SUBSURFACE WASTEWATER DISPOSAL SYSTEM APPLICATION

Town Or Plantation	AUGUSTA
Street Subdivision Lot #	B+L DUMONT SUB. L-8

AUGUSTA PERMIT # 831 TOWN COPY

SUBSURFACE WASTEWATER DISPOSAL PLAN

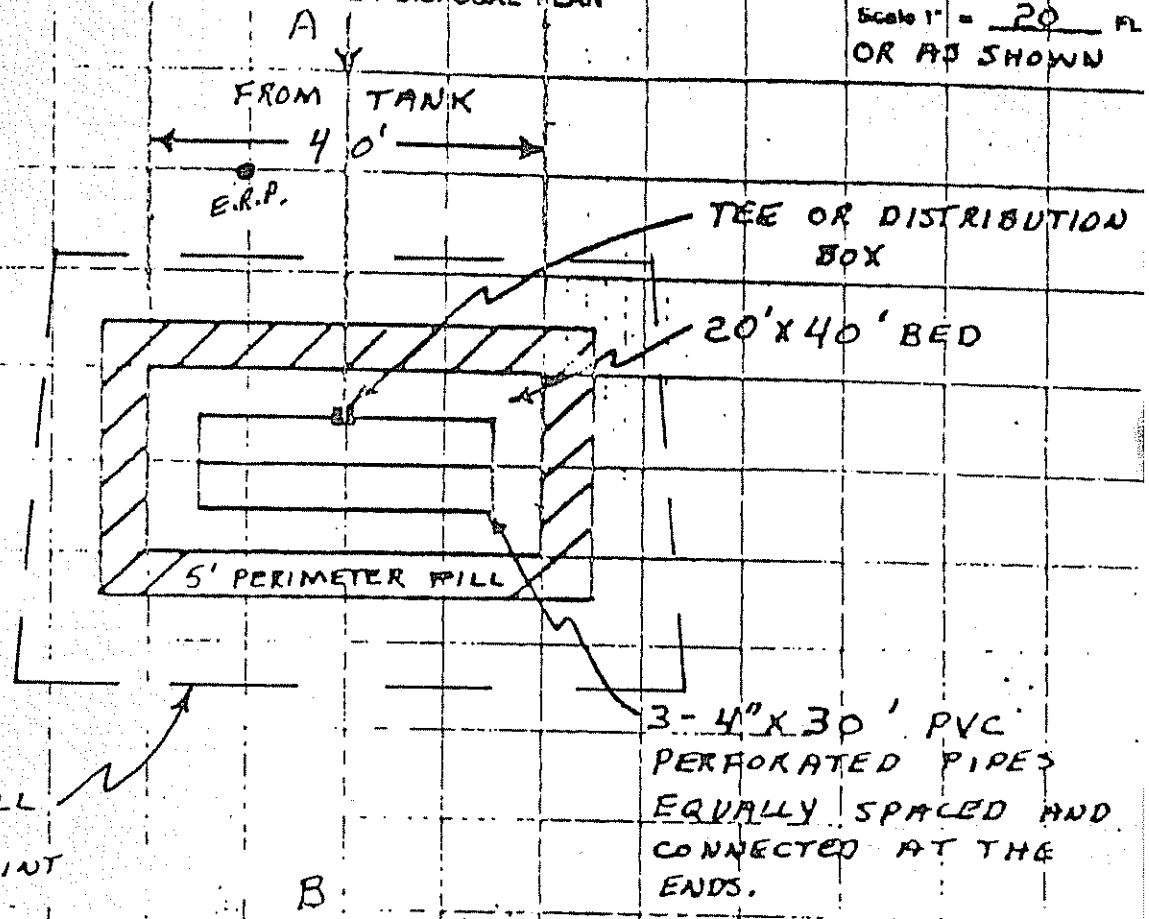
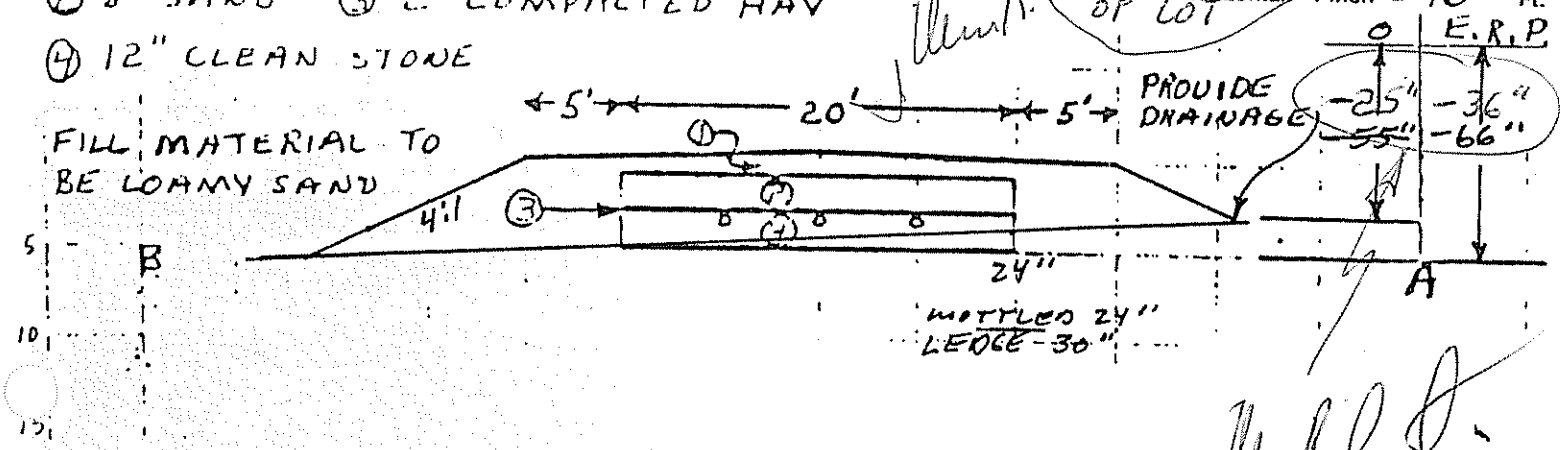
5-15-87 Mr. Richard will submit new elevations reference.

FILL REQUIREMENTS		CONSTRUCTION ELEVATIONS		ELEVATION REFERENCE POINT LOCATION & DESCRIPTION
Depth of Fill (Upslope)	18"	Reference Elevation is	0	~~NAIL IN 4" BEECH~~
Depth of Fill (Downslope)	24±	Bottom of Disposal Area	-36" ~~-66"~~	NEW E.R.P. = TOP OF I.P. & APPROX. S.W. CORNER OF LOT
		Top of Distribution Lines or Chambers	-25" ~~-55"~~ 37	Scale: Vertical: 1 inch = 5 Ft. Horizontal: 1 inch = 10 Ft.
